Noise submissions for Te Kowhai Airpark

Tonkin & Taylor Ltd (T+T) has been requested to provide acoustic advice to Waikato District Council (WDC) regarding the Proposed Waikato District Plan (PWDP), specifically around the treatment of noise from Te Kowhai Airpark. The work has been done in accordance with our engagement dated 17 January 2020.

To:	Emma Ensor	Job No:	1013185
From:	Darran Humpheson	Date:	30 October 2020
Subject:	Te Kowhai Airfield airnoise contours

Enclosure 1 – Airnoise boundary 65 dB Ldn and outer control boundary 55 dB Ldn (T+T original – blue contours and MDA assumptions yellow/orange)

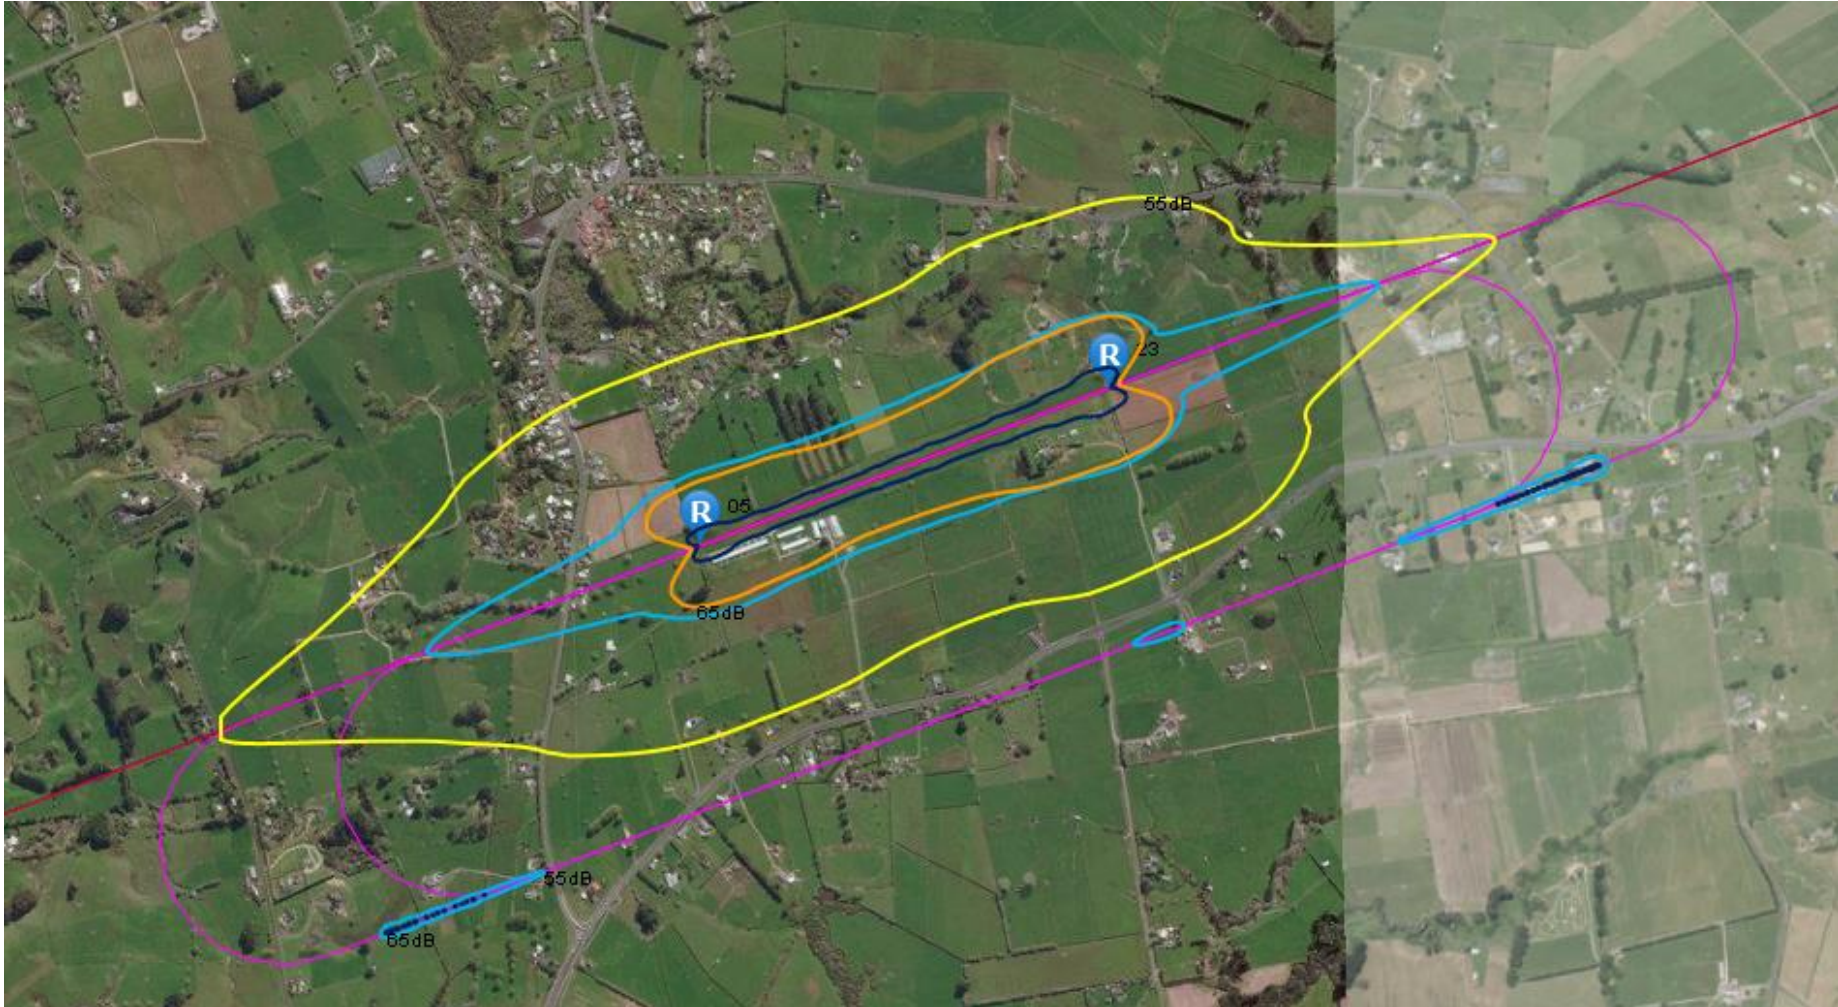
We can confirm that on the basis of the MDA input data near identical contours have been produced to those in the MDA CAN using standard flight profiles. The additional noise contribution from taxiing aircraft has a minimal effect on the size and shape of the contours.

The differences relate to the choice of aircraft in T+T's original noise model and those provided by MDA:

The choice of variable pitch propellor aircraft (Item 2) is the reason why the T+T contours are smaller than those in the MDA CAN (in addition to accounting for about ~65% of daily movements).

The T+T choice of aircraft is recognised to be quieter than a generic piston engine aircraft (GASEVF) and is representative of more modern aircraft which generate less noise when taking off and landing. As the Te Kowhai Airfield air noise boundary (ANB) needs to represent a likely future noise situation it is reasonable to assume that aircraft will be updated in the future and it is likely that quieter aircraft will replace older and hence noisier aircraft. However if this is not the case then the ANB should be based on the aircraft assumptions provided by MDA.

Without further breakdown of actual and future aircraft types at Te Kowhai Airfield we are reliant on the aircraft assumptions provided by MDA but do note that the contours are likely to over-estimate the degree of aircraft noise around the airfield.
